Rubicon and Razorback Generator

It has been determined the vehicles in this technical service bulletin population may have been manufactured without an air diverter on the output over the Frame I-beam. Generators installed without the diverter may shut down in high ambient temperatures.

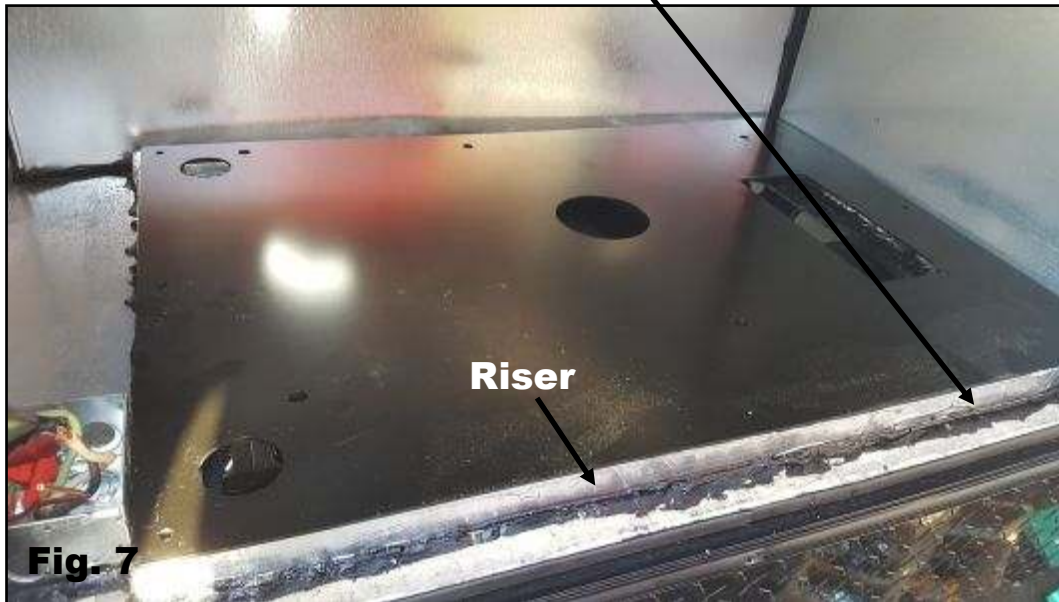
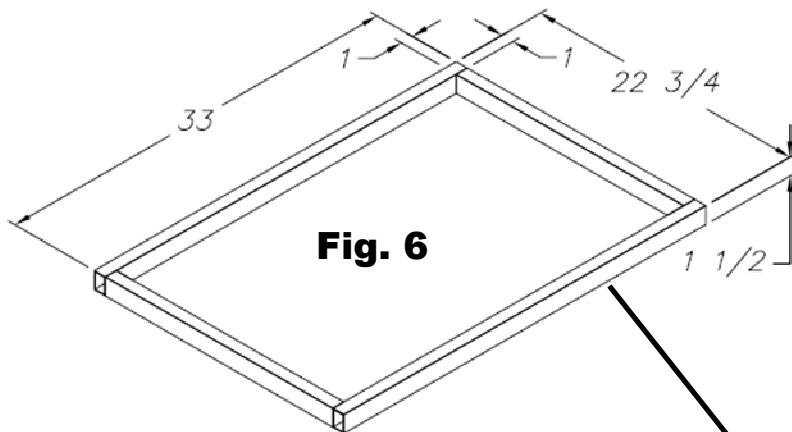
Locate mounting bolts under generator and remove all. There are 6 available mounting bolts. Onan requires 4 mounting bolts, 2 towards the front of the mounting plate and 2 towards the rear. After mounting the riser some holes may not be accessible. Refer to Fig. 1 and Fig. 2.

Remove fuel line and return line, remove positive wire, remove 120v wiring in junction box, and remove harness, Fig. 3.

Remove generator and mounting plate from the cavity, Fig. 4 and Fig. 5.

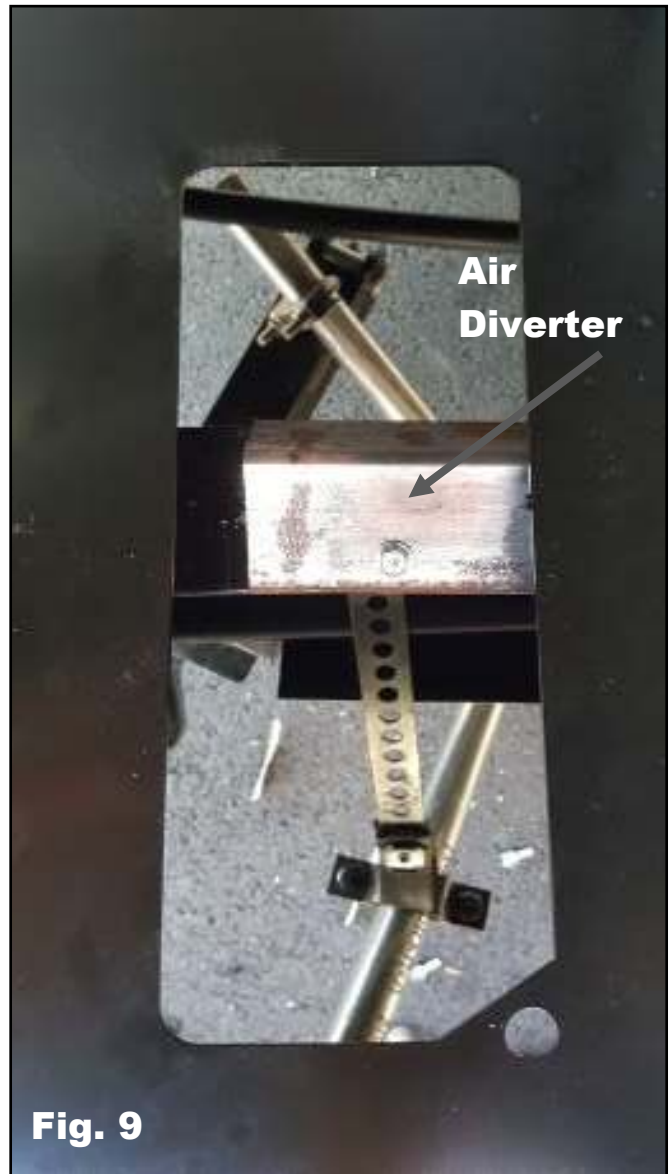
Install the air diverter over frame I-beam using any type of self-tapping screws or tack weld to keep in place, Fig. 8 and Fig. 9.
